SERVICE BULLETIN - OPTIONAL

Part No.: LS300-20x Loudspeakers

Service Bulletin No.: ASM-LS-603-0006

Subject: Re-entrant Tip Securing (MOD 4)

Figure 4 – Old Doubler Plate Removal

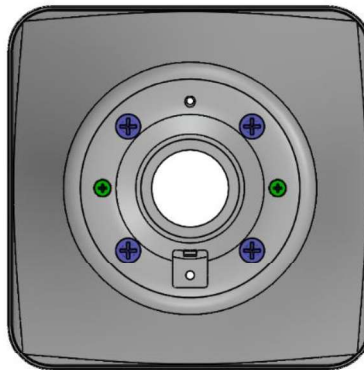
Note: For Loudspeakers with MOD 2, a Locking Tab may separate from the Doubler Plate during removal of the Re-entrant Tip. Ensure any tab debris is removed and discarded from the Speaker Assembly.

- 2.2.1 Per Figure 4, remove two #2 Phillips Screws (shown in green) and four #3 Phillips Screws (shown in blue). Remove and discard Doubler Plate and all screws. Remove old Threadlocker from threads.

Figure 5 – New Doubler Plate Installation

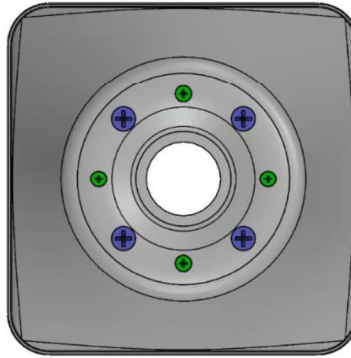
- 2.3.1 Place new Doubler Plate (150-08-035) inside the bell and align its holes with the holes in the bottom of the bell.
- 2.3.2 Per Figure 5, apply LOCTITE® 271 to four #3 Phillips Screws (shown in blue) and torque to 30 in-lb. Torque four #2 Phillips Screws (shown in green) to 9 in-lb. Do not apply LOCTITE® 271 #2 Phillips Screws.

Note: LOCTITE® 271 sets in 10 minutes and fully cures in 24 hours.

Figure 7 – LOCTITE® 222 Locations for Re-Entrant Tip Replacement

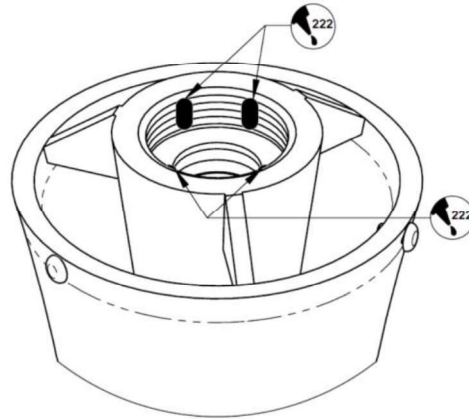
- 2.4.2 Per Figure 7, apply four thin strips (approx. 0.25" wide) of LOCTITE® 222 to Re-Entrant Tip threads.

Note: LOCTITE® 222 sets in 10 minutes and fully cures in 24 hours.

Figure 8 – Wrench Adapter Assembly Position on Re-Entrant Tip

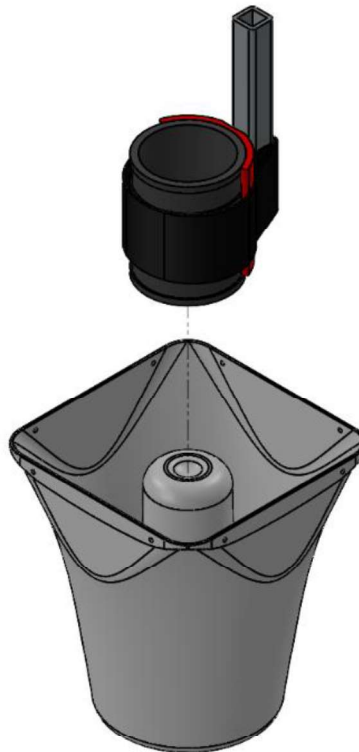
- 2.4.3 Thread Re-Entrant Tip to Speaker Assembly until hand tight. Per Figure 8, affix Wrench Adapter Assembly (WA-001 and 156-99-005) to Re-Entrant Tip. Ensure Wrench Adapter Assembly is fully seated on Re-Entrant Tip and does not contact Loudspeaker Bell. Surface damage to the Bell may occur if the Wrench Adaptor contacts it during rotation.
